May 14, 2007
NRC-07-0009

Subject: Submittal of Proposed Revision to the Fermi 2 Radiological Emergency Response Preparedness Plan (RERP Plan)

**PROPOSED CHANGES
AND
JUSTIFICATION FOR
FERMI 2 RERP PLAN REVISION**

ELECTRONIC MARK-UPS
OF PROPOSED CHANGES TO
FERMI 2 RERP PLAN

**FERMI-2 RADIOLOGICAL EMERGENCY
 RESPONSE PREPAREDNESS PLAN**
 Figure B-5
**EMERGENCY RESPONSE ORGANIZATION
 TECHNICAL SUPPORT CENTER SITE AREA
 EMERGENCY AND/OR GENERAL EMERGENCY**

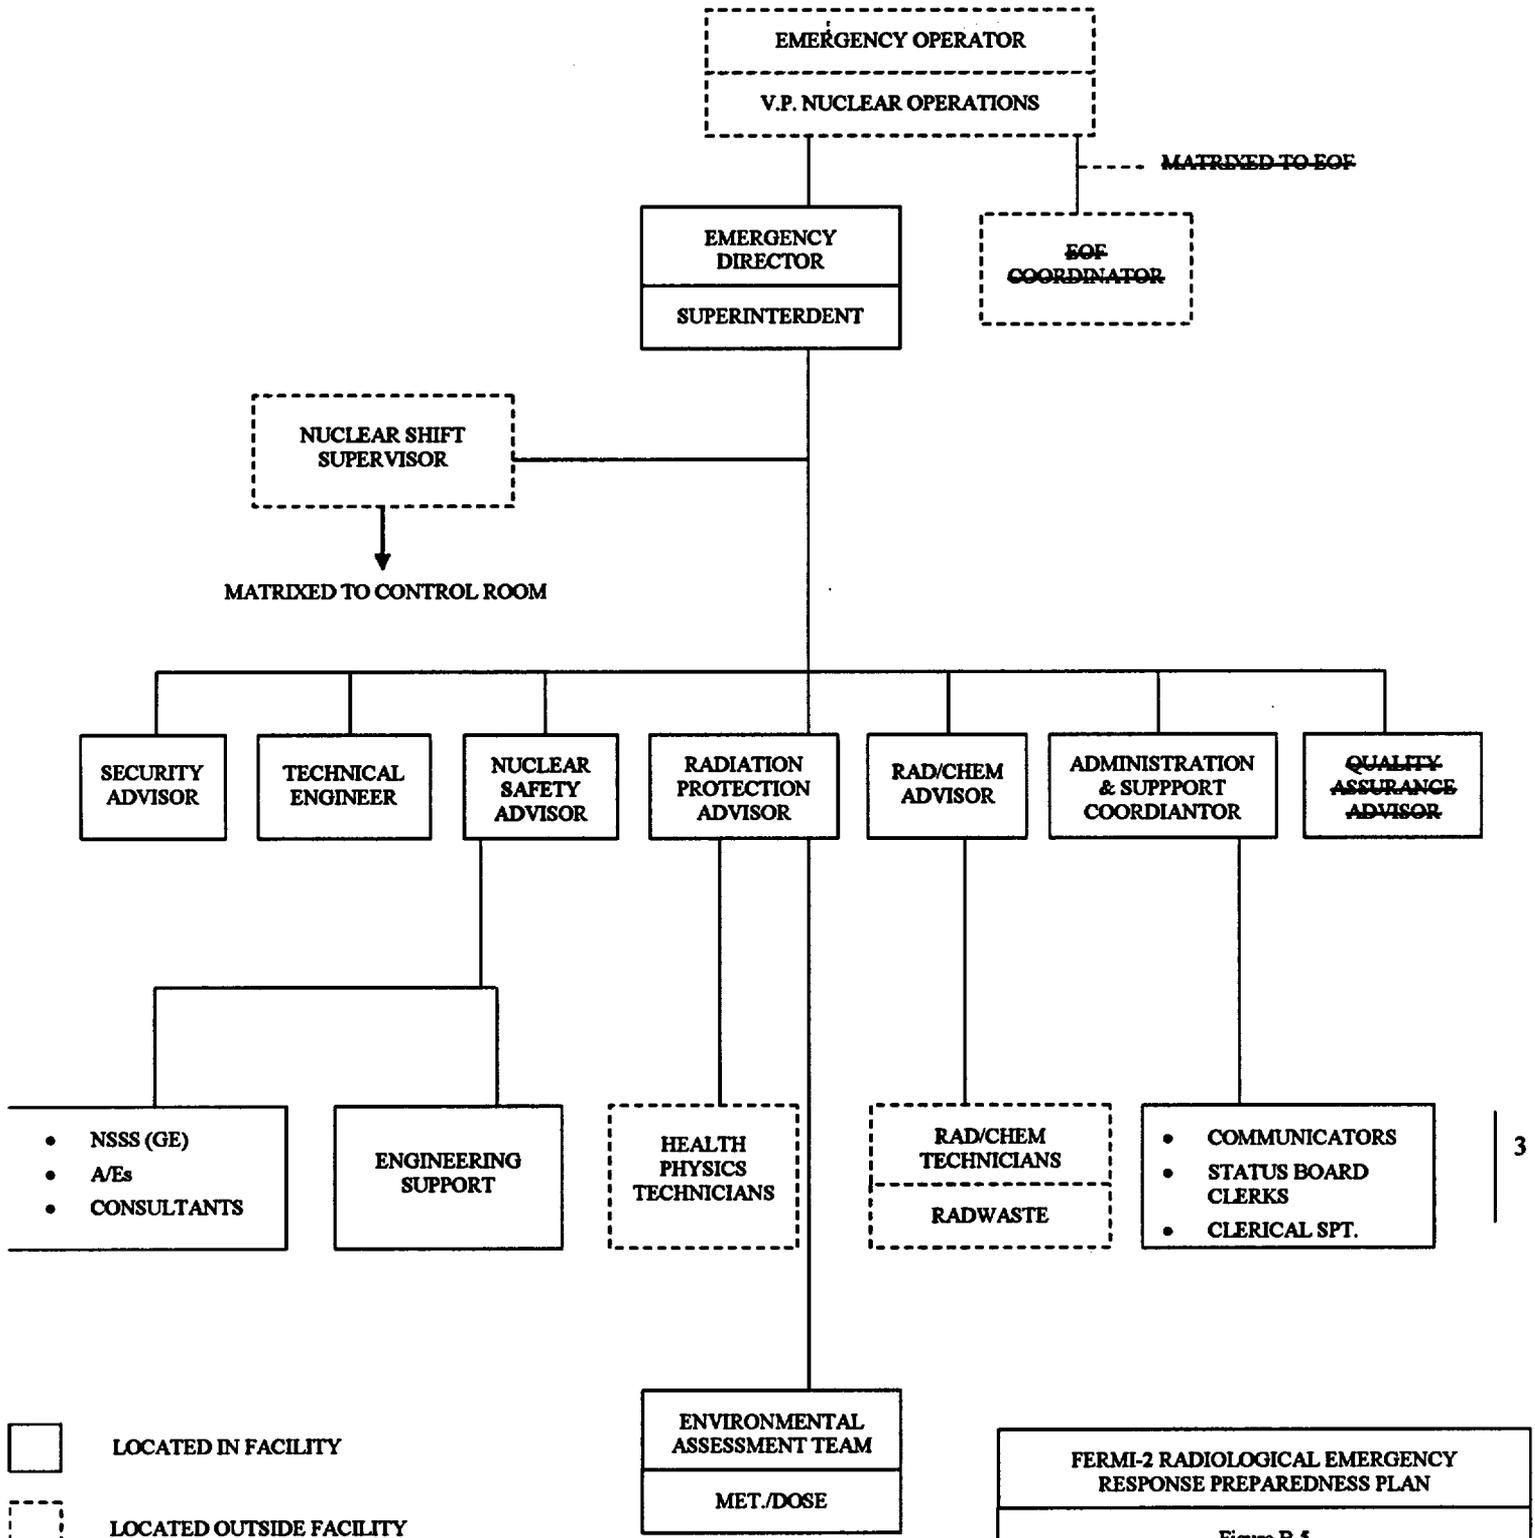
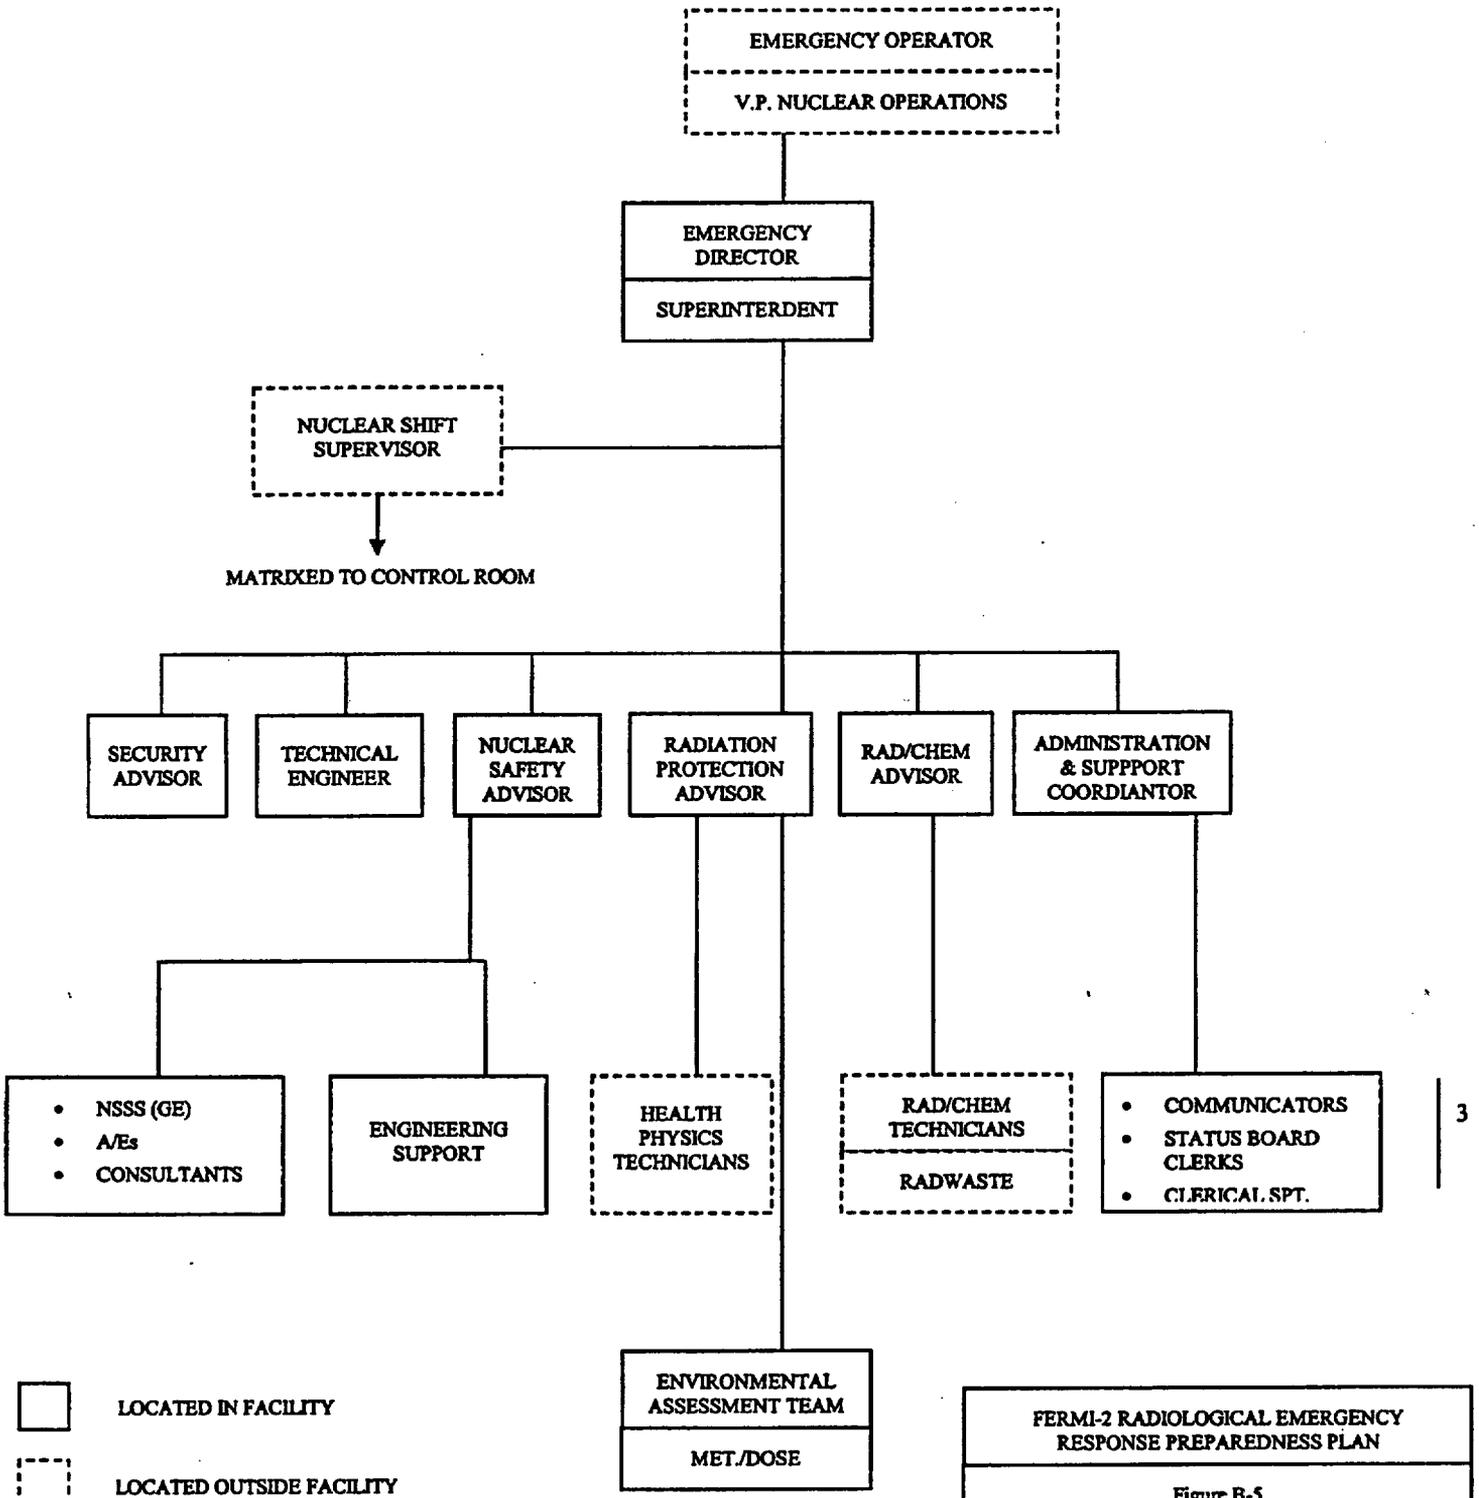
Delete the EOF Coordinator position.

Revision 3A - Table B-2, pg. B-17, 18, 20, and 21, Figures B-5 and B-6 (no page numbers identified)

Delete the Quality Assurance (QA) Advisor position.

Revision 3A - Table B-2, pg. B-16, Figures B-4 and B-5 (no page numbers identified)

In revision 3A, the EOF Coordinator was identified as the person who directed activities in the EOF. This contradicts Table B-1 which states the Emergency Officer is responsible for overall management and control during the event. The Emergency Officer is an augmented position; the EOF Coordinator is not an augmented position. The Emergency Officer actually directs activities in the EOF and provides oversight in all areas of offsite response including activities in the EOF which support these efforts. As reflected in revision 32, the EOF Coordinator position was eliminated in March 1988. Multiple drill and exercises have been evaluated since that time and there has been no decrease in performance in the EOF staff. Direction and control of EOF activities is maintained with no loss of functionality. Therefore, there is no decrease in effectiveness as a result of this change.

Therefore the QA Advisor position is not needed for the initial response of an emergency. The Manager - NQA as part of the Recovery Organization and as such will ensure the QA requirements are met. The function has been maintained, therefore, there is no decrease in effectiveness as a result of this change.
